UN Regulation No. 44 (Child restraint systems)**Proposal for Supplement 14 to the 04 series of amendments
to UN Regulation No. 44 (Child restraint systems)****Submitted by the expert from France***

The text reproduced below was prepared by the expert from France on behalf of the Technical Services Group (TSG) on UN Regulation No. 44 to clarify the test protocol for the opening force of the ISOFIX attachments. The modifications to the current text of UN Regulation No. 44 are marked in bold for new or strikethrough for deleted characters.

"Figure 7

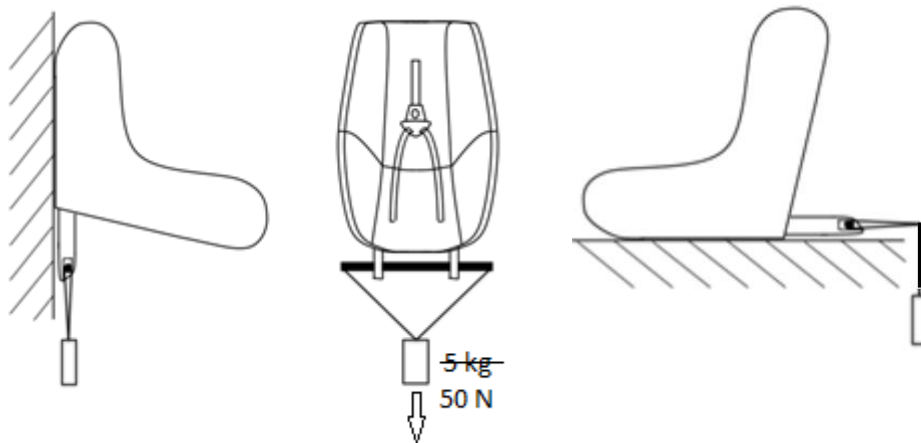
"8.2.9. The complete seat, or the component fitted with ISOFIX attachments (e.g. ISOFIX base) if it has a release button, is attached rigidly to a test rig in such a way that ISOFIX connectors are ~~vertically~~ aligned as shown in Figure 7. A 6 mm diameter bar, 350 mm long, shall be attached to the ISOFIX connectors. A ~~mass force of 5 kg~~ **50 ± 1 N shall be applied to the** ~~shall be attached to the~~ extremities of the bar."

Figure 7, amend to read:

Either option is permitted as long as a force of 50 N is applied.
